# NRC INSPECTION MANUAL

## INSPECTION MANUAL CHAPTER 0609 APPENDIX D

#### PUBLIC RADIATION SAFETY

#### DRAFT REVISION FOR EXTERNAL STAKEHOLDERS

# Package Breach

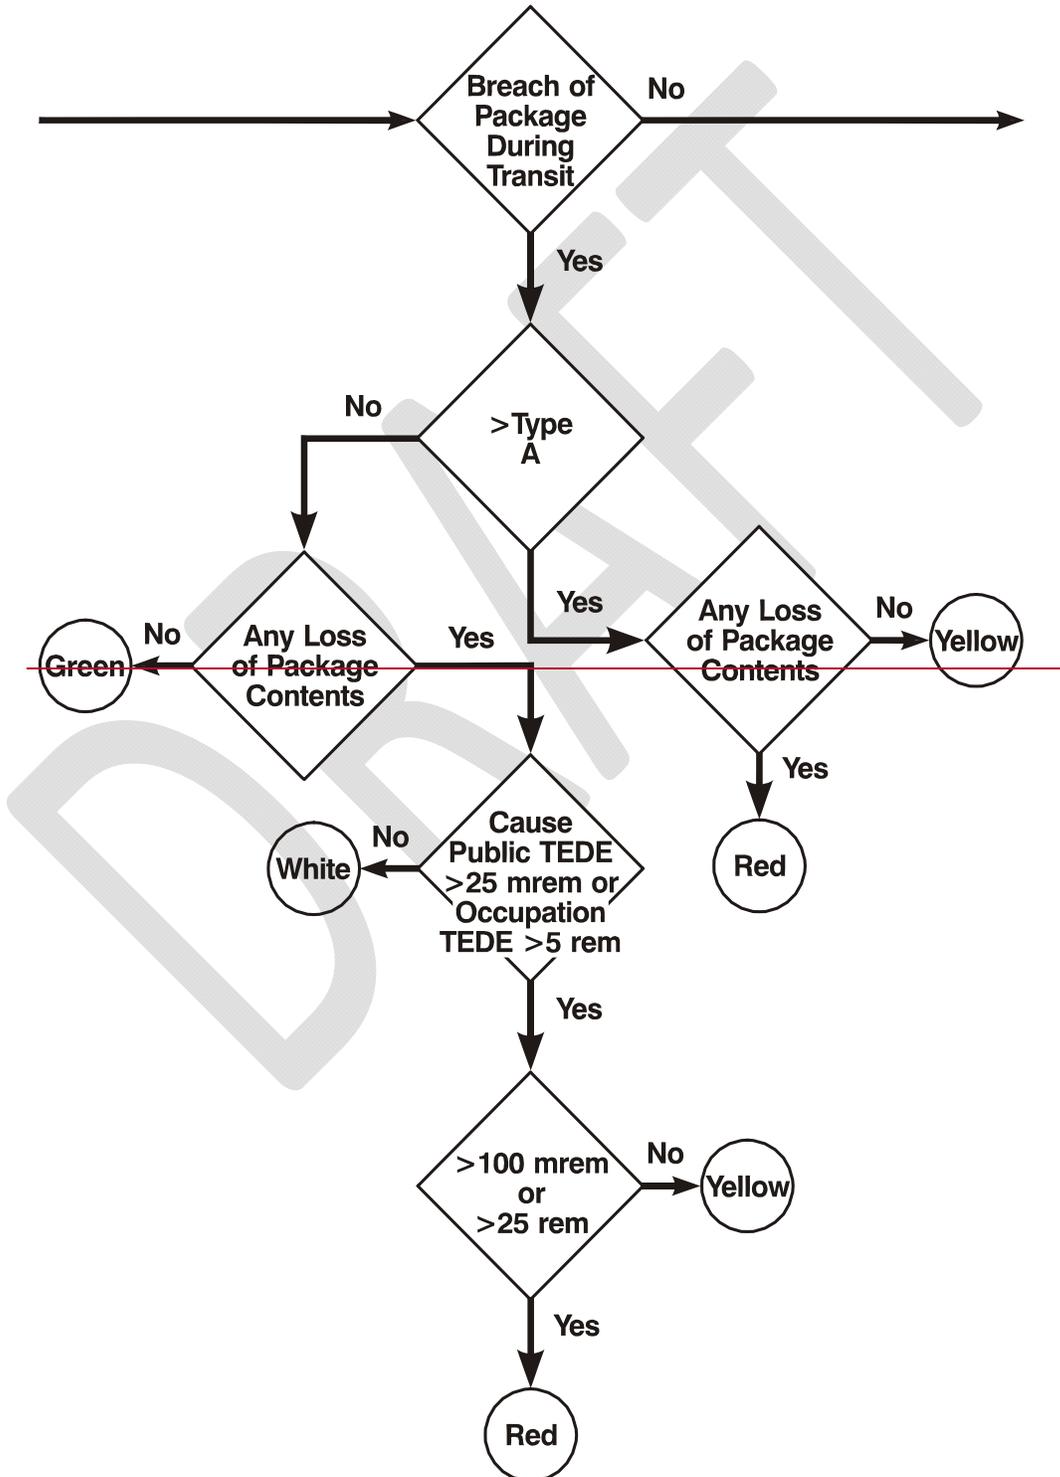
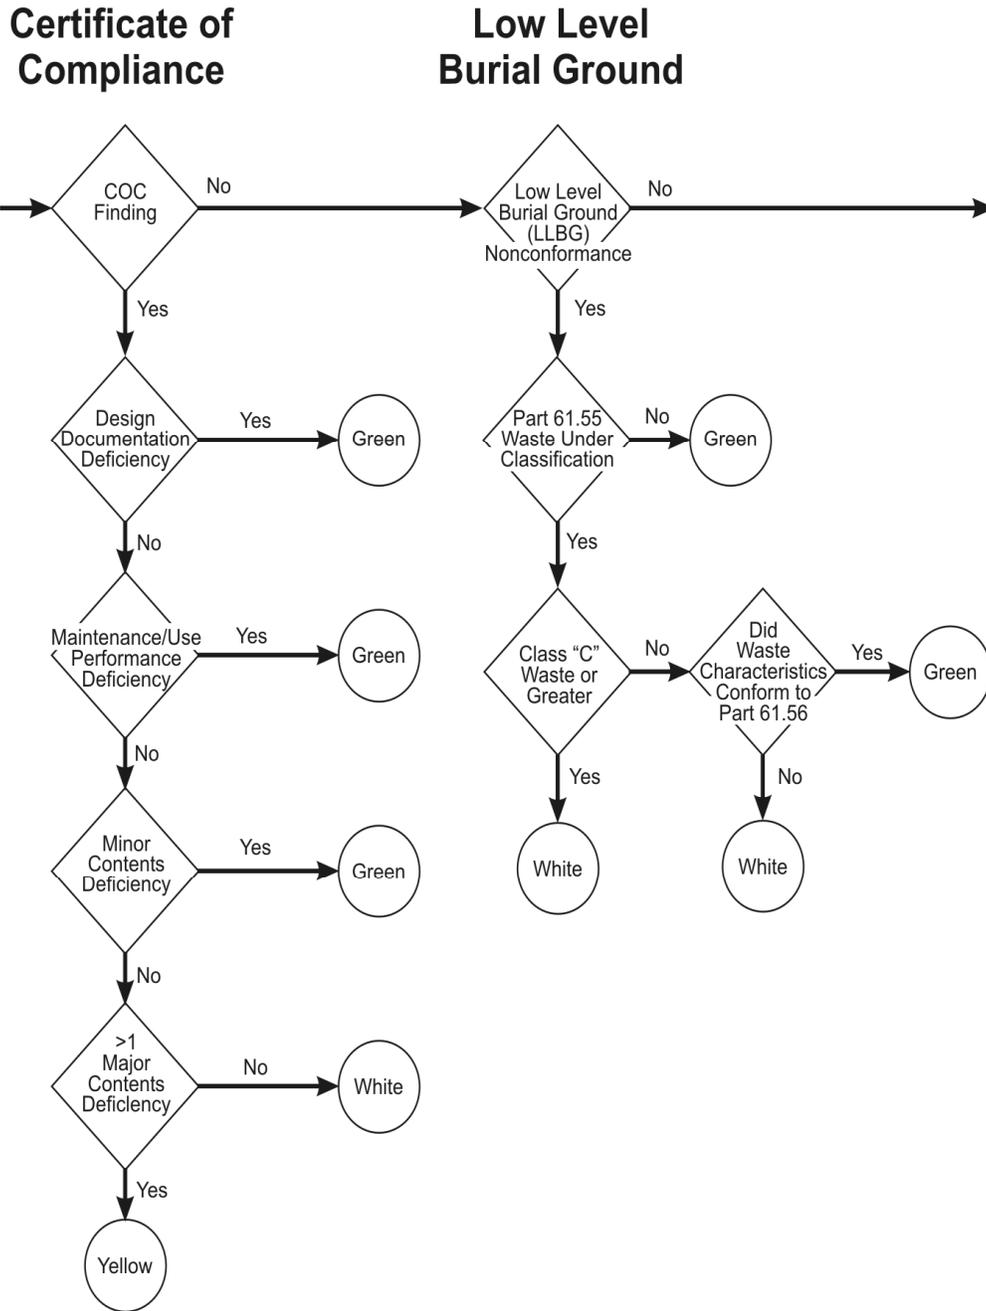
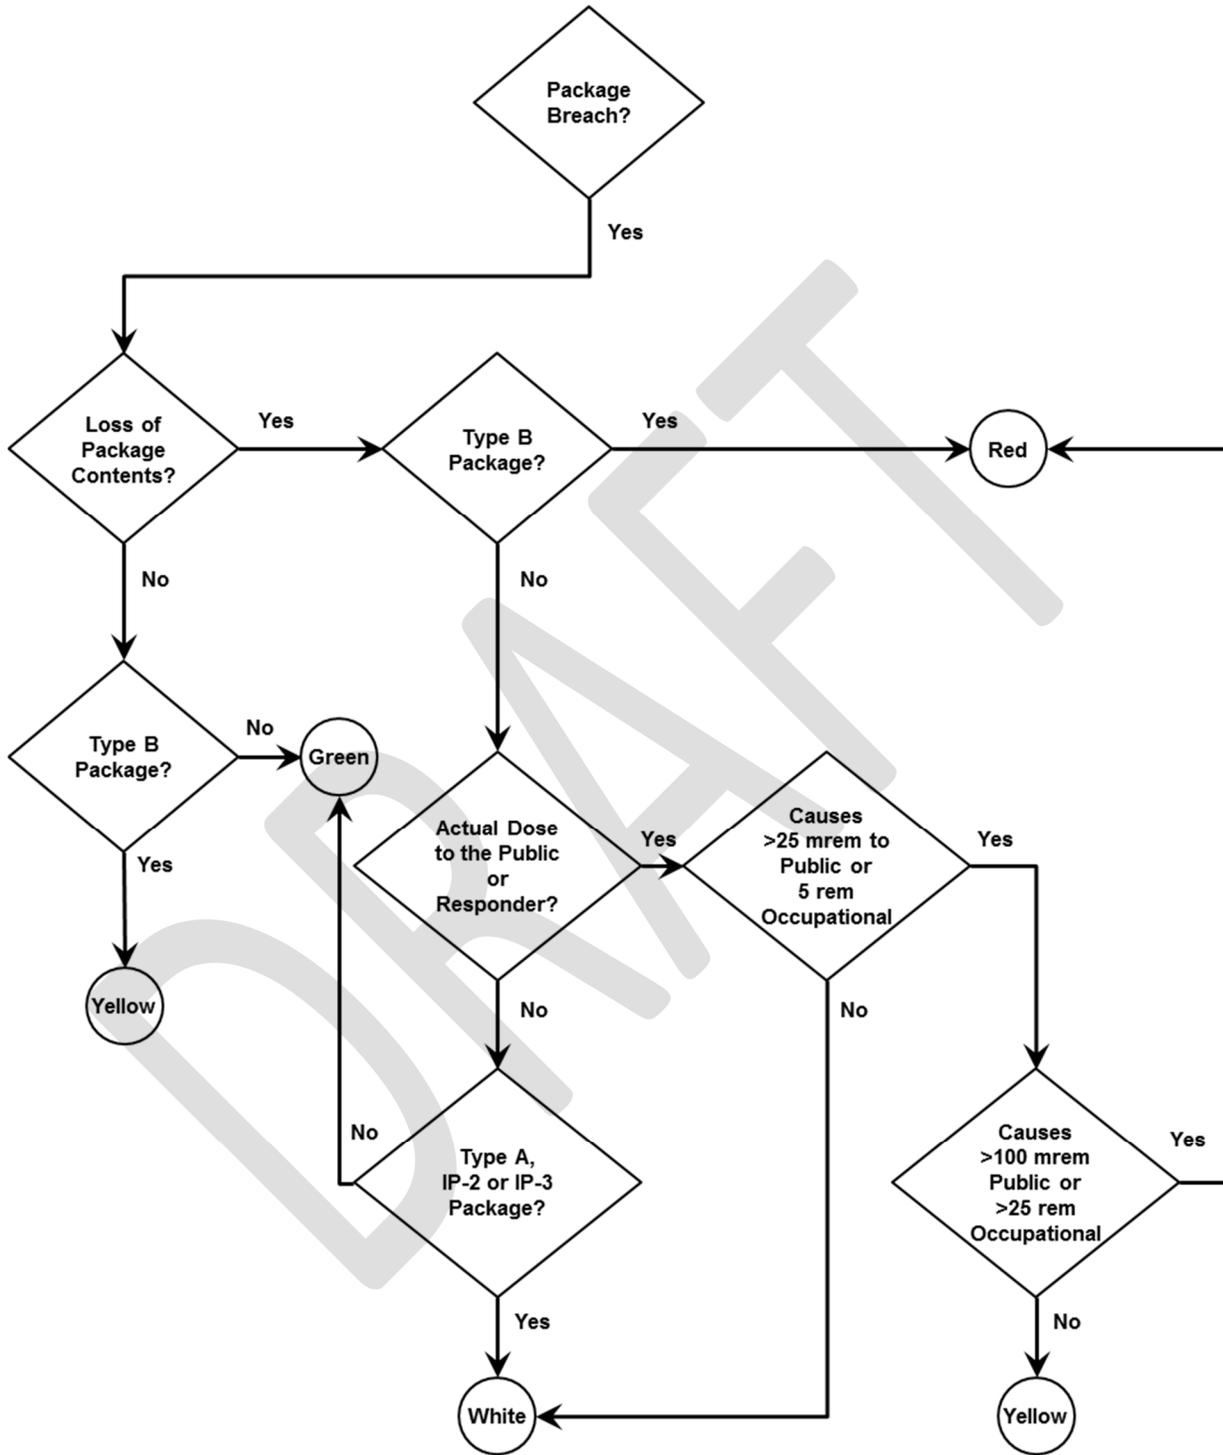
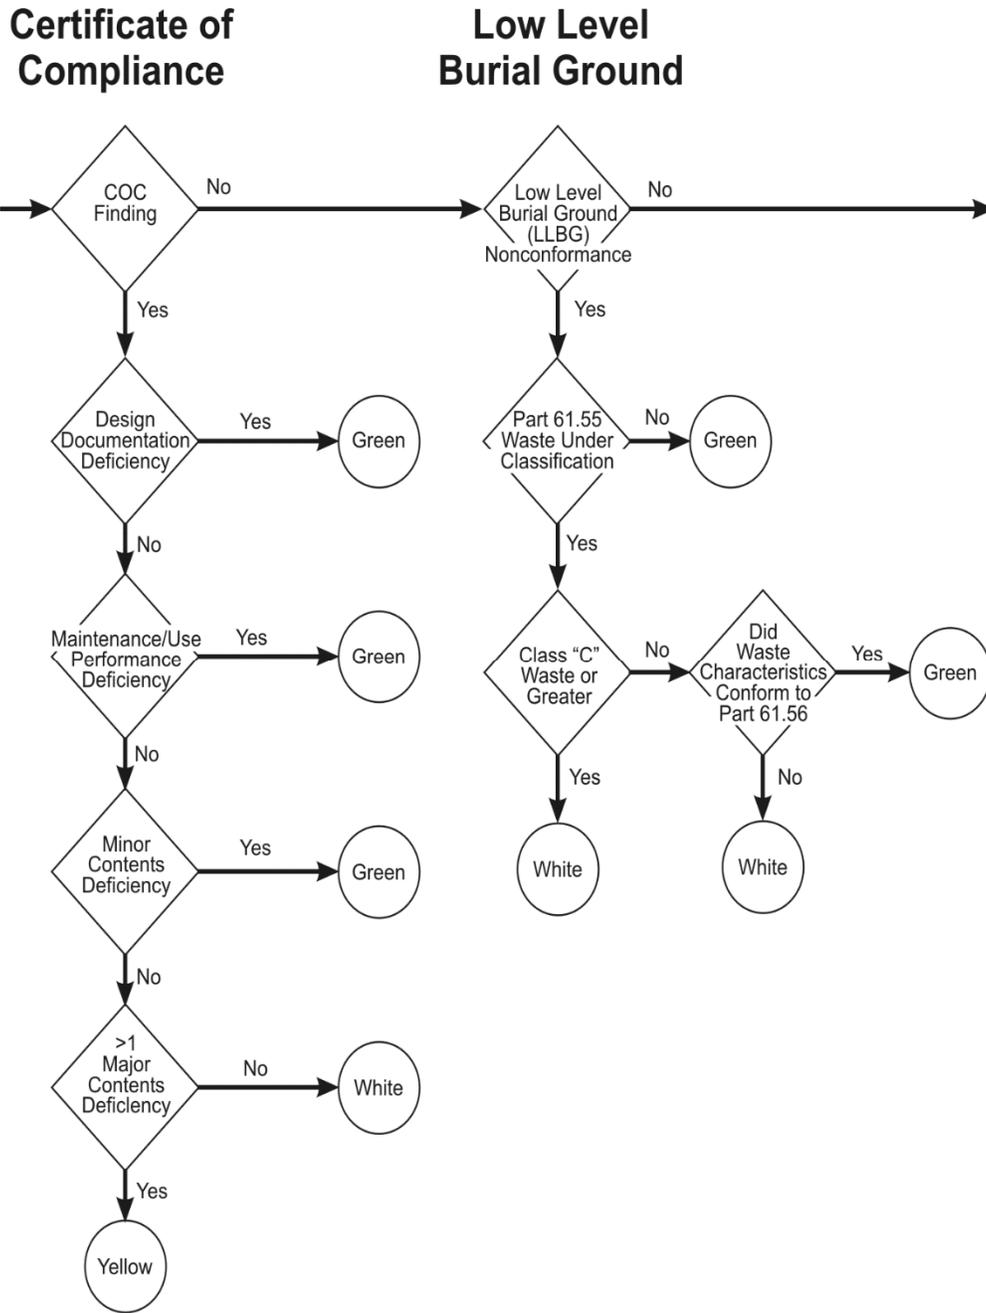
In the logic diagram, when a decision block asks for a package type (e.g., "Type B Package?"), it is asking, what type of packaging was actually used for the shipment in question. In some cases shippers use packaging of a higher tier than is required by the DOT regulations. However, the expectations for integrity of the higher tier package are not relaxed because the package is used to ship material that is less radiologically significant. Finally, the DOT regulations allow the use of certain types of Industrial Packages (IP) when shipping certain types of LSA or SCO; therefore, for the purposes of this the logic diagram, IP-2 and IP-3 packages are treated in the same manner as Type A packages.

~~The less than or equal to Type A shipment~~The "Package Breach" branch provides for a graded approach for assessing the level of significance of findings. If a breach in a Type A or lesser container occurs as a result of the failure to meet transportation requirements, but no loss of control of the contents is evident, then the finding is GREEN. An example could be a solidified radwaste liner, inside a Type A package where the closure lid was loose (not tightened down). In this case, given the form of the radioactive contents, loss of control of the material is very unlikely. However, on a similar shipment, failure to properly torque the closure lid bolts (35 ft-lbs- versus required 45 ft-lbs-) is not a breach, assuming the licensee analysis demonstrates that package integrity would be maintained during the normal conditions of transport. If package integrity was not maintained for a Type A package, and the result was a loss of contents<sup>2</sup> then a WHITE finding would be appropriate. As previously discussed, failure to maintain integrity with a loss of contents for a general design package is assigned a lower significance and would be GREEN.

While power reactor shipping history has demonstrated that serious mishaps are highly unlikely, if a transportation incident occurs with a package breach, then public dose consequences could result. ~~The next two blocks in~~To address this, the Type A "Package Breach" branch (assuming has a breach) focus section that focuses on public and occupational doses that occur as a result of the loss of control of package contents. These are actual doses to real individuals, and depending on the level, would lead to either WHITE, YELLOW or RED findings.

The ~~greater than~~-Type AB section of the "Package Breach" branch provides for a YELLOW finding, assuming no loss of control of package contents. A RED finding would result if package ~~contents control~~containment was lost resulting in the release of material that was distinguishable from background. An example of a YELLOW finding is where a receiving facility finds the incoming shipment (irradiated components) ~~package~~package's drain valve ~~on the package~~open ~~presenting~~ a direct pathway to environment, ~~but, assuming normal conditions of transport,~~ no potential for loss of control of materials ~~(assuming normal conditions of transport), occurred because of the type of material being shipped~~. A RED finding is appropriate for the same ~~A "open valve"~~ scenario if the package contents were spent fuel ~~could feasibly have been~~ released continuously to the environs during the shipment, assuming normal conditions of transport. ~~However, in the event of a transportation accident that led to loss of fuel integrity, public dose consequences could exceed acceptable levels before adequate protective measures could be implemented.~~

# Notification & Emergency Information

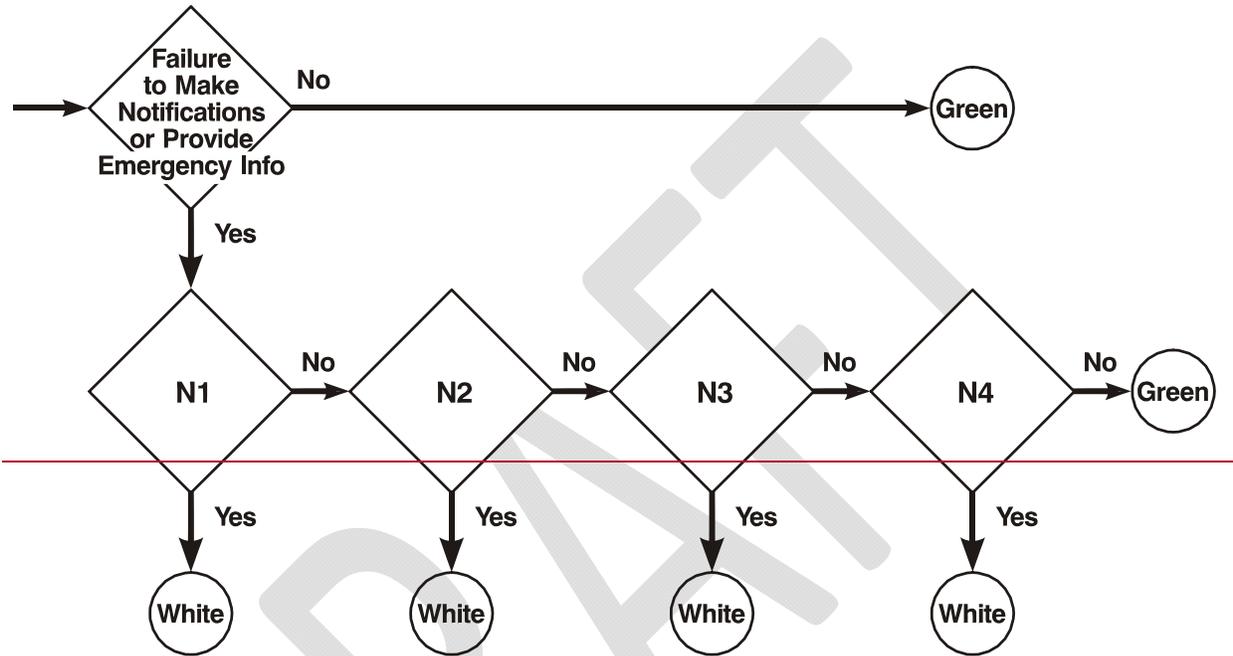
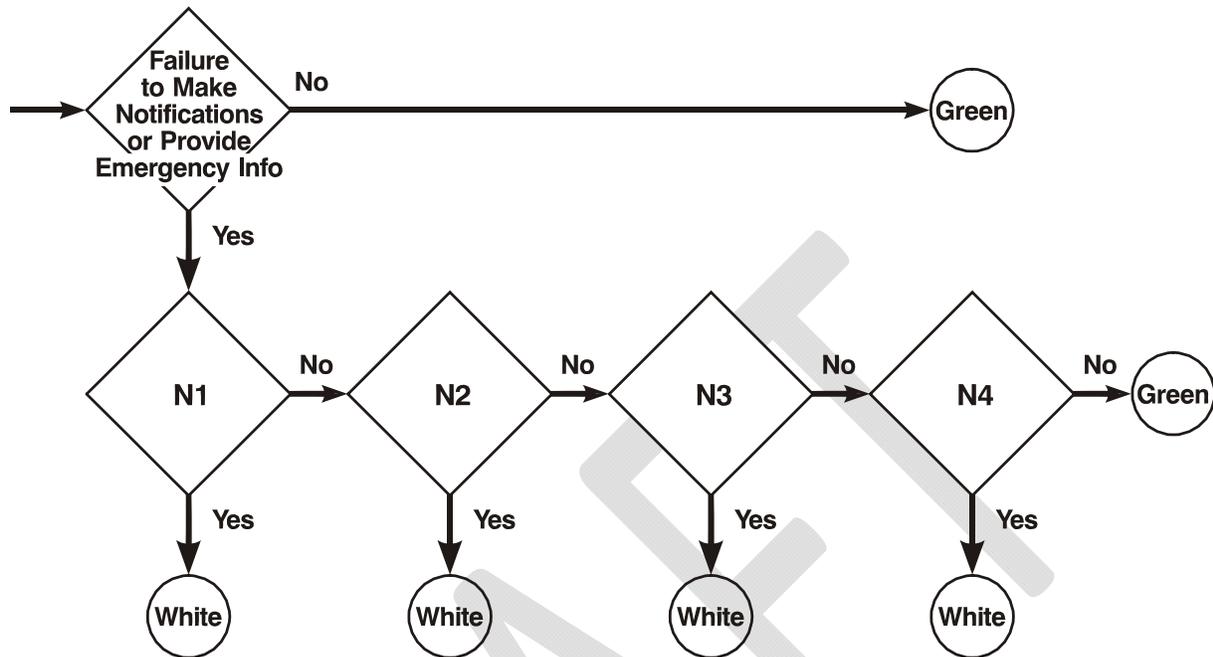
For Block N1 (10 CFR 71.97 ~~non-compliance~~), if the licensee fails to make the required notifications to the governor of a State, or the governor's designee, before the shipment entered the ~~State's~~ State's boundary (crossed the State line) for interstate shipments, the finding would be WHITE. For intrastate shipments, if the shipment was put on public roads/rails before the Governor, or his designee, received the required notification, then a finding would be WHITE. Note that for any other timeliness non-compliance (e.g., notification not postmarked at least 7 days before the 7 day shipment period), these findings would be GREEN. Failures to notify the NRC when required by the regulations are typically dispositioned using traditional enforcement because these failures result in an impediment to the regulatory process.

For Block N2 (49 CFR 172.602 non-compliance), if the licensee fails to provide the required emergency response information to the shipment carrier (the shipment leaves the ~~licensee's~~ licensee's facility and control without the required information), the finding is WHITE. If the carrier misplaces or loses the information (beyond the ~~licensee's~~ licensee's control), the finding is GREEN.

For Block N3 (49 CFR 172.604 non-compliance), if during an actual emergency the licensee does not respond in a timely manner in accordance with the requirements (or had not provided the 24-hour telephone number), the finding is WHITE. For an incorrect or missing emergency response telephone number as required by 49 CFR 172.604, if there were no actual accidents or situations where the emergency contact information was needed, then the risk significance would be minimal and the finding is determined to be Green.

For Block N4 (10 CFR 20.1906), if the ~~licensee's~~ licensee's receipt surveys show 1) the package's external radiation levels in excess of five times the Part 71 limits, or 2) the surface radioactive contamination level in excess of five times the Part 71 (49 CFR 173) limits, and the licensee facility fails to make an immediate report, then the finding is WHITE. Other non-compliances are GREEN.
